Orient Allure Lingerie Ltd. (Unit - 2)

14 May 2025

Observation-01: Inconsistencies in the design report & design seismic base shear. (Production Building)

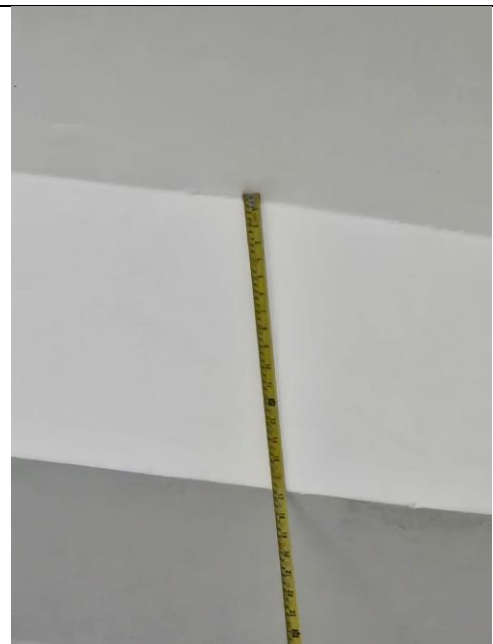
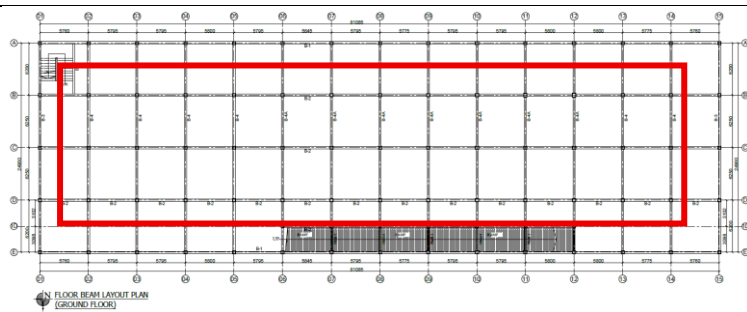
No information on Column Tie Bar in Column Schedule

Considering R=5 OMRF, Columns found overstressed

Description: Inconsistencies were found in the design report and design seismic base share considering the framing system. As per the drawing and on-site observation, columns do not meet the IMRF requirements. On-site column tie bar spacing at the support was found to be 6 inches (150 mm) instead of 5 inches (125 mm). Considering the OMRF, several columns were found to be overstressed.

Building engineer is required to check the onsite conditions and address all the inconsistencies in the design report.

Fig- 1st Floor Beam Reinforcement

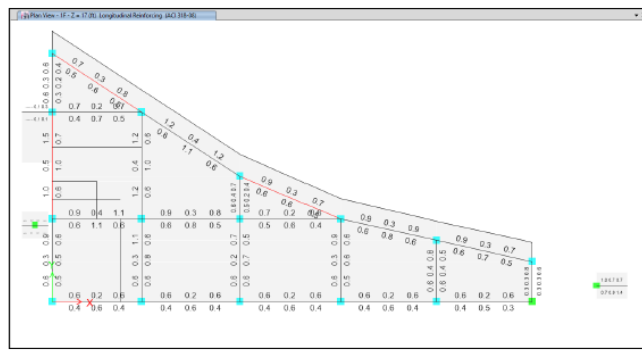
Description: The shape of the building is irregular. A design report was available considering BNBC 2020. But different types of irregularity checks were not provided in the report. The building engineer is required to address the inconsistencies in the design report and submit revised design documents to RSC for review.

Observation-10: Falling Hazard (ETP Building)

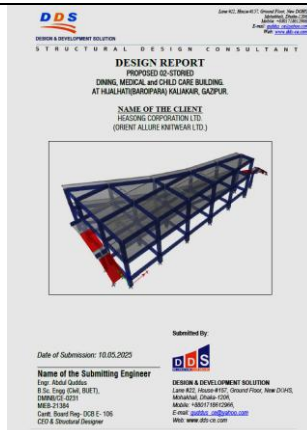
Description: Falling Hazard observed on the ETP building. The building engineer is required to provide safety guard/ handrails.

Observation-11: Inconsistencies in the design report. (ETP Building)

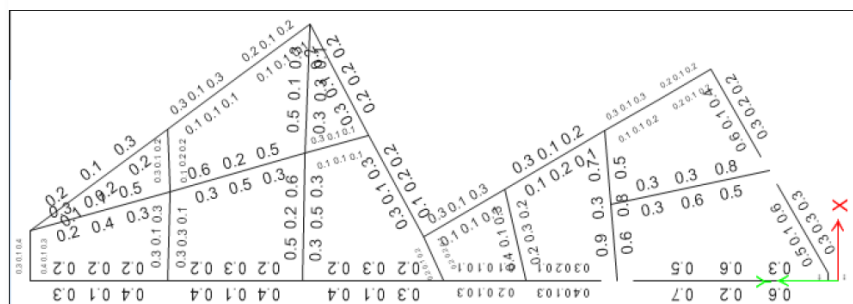
Description: The shape of the building is irregular. A design report was available considering BNBC 2020. But different types of irregularity checks were not provided in the report. The building engineer is required to address the inconsistencies in the design report and submit revised design documents to RSC for review.
